**SUBMITTAL OF COMMITMENT RESOLUTION LETTER #7 INFORMATION  
DOCKET NO. 72-22 / TAC NO. L22462  
PRIVATE FUEL STORAGE FACILITY  
PRIVATE FUEL STORAGE L.L.C.**

**ENCLOSURE NO. 1 – GEOTECHNICAL PROGRAM**  
**COMMITMENT RESOLUTION LETTER NO. 7 – JUNE 30, 1999**

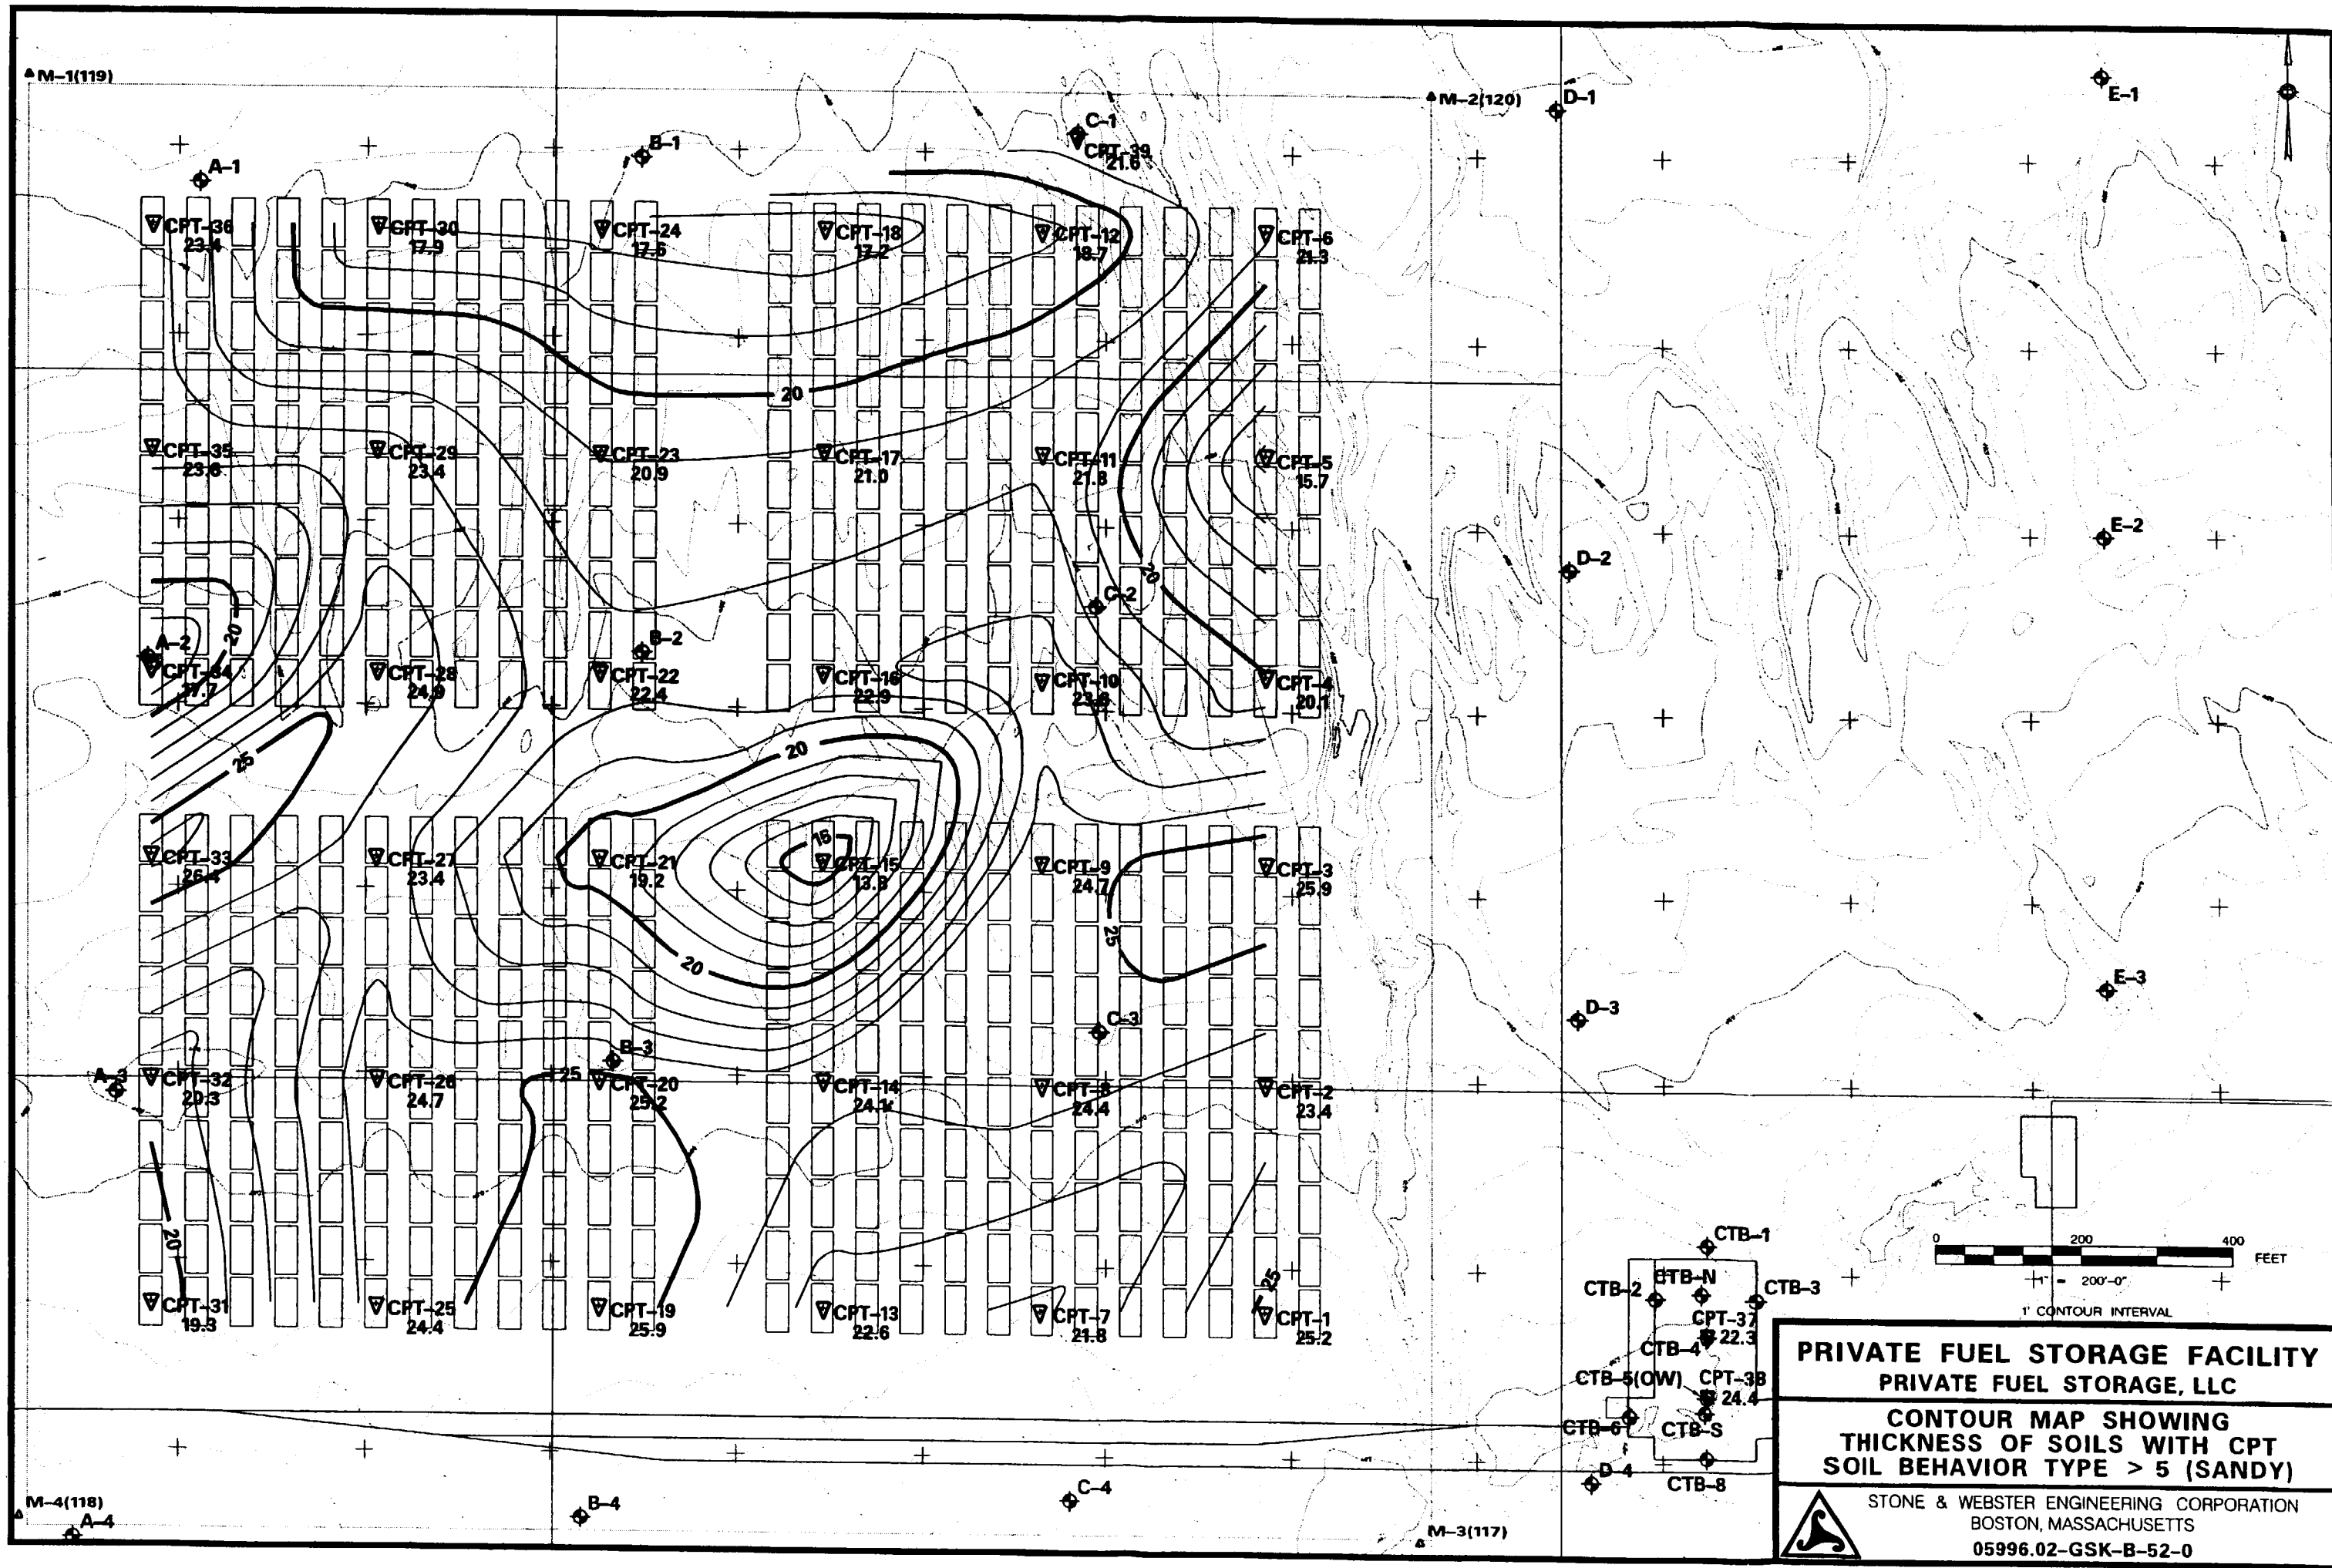
**Item 1: The cone penetrometer testing (CPT) data that PFS submitted on May 28, 1999 (ConeTec, 1999) indicates that the soil classifications based on the CPT data include sandy silts, silty sands, and sands in the upper 25 to 30-ft layer, where PFS previously has reported that this layer consists of uniform silt, silty clay, and clayey silt. PFS should develop a map showing the areas where the sandier soils exist.**

The purpose of the request that PFS provide a map showing the areas where the sandier soils exist was to readily identify those areas where the subsurface profile differs from the assumption that the soils in the upper layer (~25 to 30 ft) are predominantly cohesive. A review of the CPT data (ConeTec, 1999) indicates that most of the soil behavior type (SBT) values represent soils whose behavior is similar to that of "sandy" soils. As indicated in Figure 5 of ConeTec (1999), these include SBT values that are greater than 5. Therefore, to respond to Item 1, PFS generated a map showing the thickness of those soils for which the behavior type values are greater than 5.

This map, titled "Contour Map Showing Thickness of Soils with CPT Soil Behavior Type > 5 (Sandy)" is included as Attachment 1. The thickness of the soils beneath the cask storage pads that behave as "sandy" soils based on the CPT data are posted under the CPT identifiers shown on this plan view of the site. These values were calculated by subtracting the top three feet, to account for the proposed depth of the pads, as well as the total thickness of all zones where the SBT value was found to be less than 6, from the total depth of the CPT. The

thicknesses were contoured to facilitate interpretation of the  $SBT > 5$  data obtained in the CPT program. As indicated in the figure, the thickness of the soils that behave as sandy soils ( $SBT > 5$ ) based on the CPT data ranges from 13.8 feet at CPT-15, near the center of the pad emplacement area, to a high of 26.4 feet at CPT-33 near the center of the western edge of the pad emplacement area. The thicknesses are generally about 20 to 25 feet.
